APPLICANT RESPONSES IN RED
10/23/20

September 2, 2020

RE: Shinglemill Apartments
Preliminary Architectural Peer Review Report

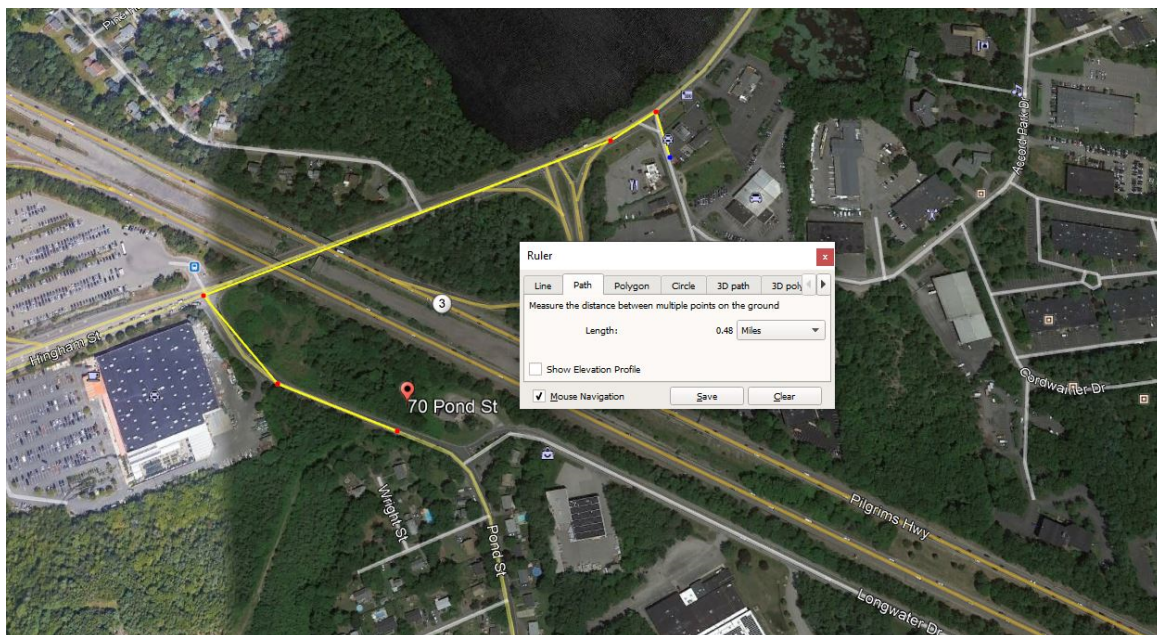
Within ½ mile of the site there is significant commercial development to the west, north, and northeast. Given the proposed circulation to the site by a single "causeway" built up off of the existing grade, or the pedestrian access through the emergency fire entry/egress through the abutting residential area, all access to the commercial uses is via Pond Street. As currently configured, there are no walkways (or bike lanes) on either side of Pond Street all the way from the proposed development driveway to where it intersects Hingham Road. The entire length of the west side of Ponds street is very tight up to a metal guard rail system that provides no space for walking except in the travel lane. Some of the east side affords a grassy strip that is wide enough in some spots that it could be used for walking. These facts, combined with the current project driveway design that does not include any sidewalks, makes the pedestrian experience on the route to Hingham Street unpleasant, potentially hazardous.

West of Site

Closest development other than Home Depot, Comfort Inn and Doubletree; is 0.68 Miles away

- Season's Café
- TKO Shea's Sports Café
- Dunkin's (may no longer be in operation)
- AAA
- Registry of Deeds
- Hair Salon
- Liquor store.

We would not consider this a "significant commercial development" or destination.

There are no sidewalks on this portion of Hingham St and it is a high traffic area that would be dangerous to pedestrian access. (see images below)
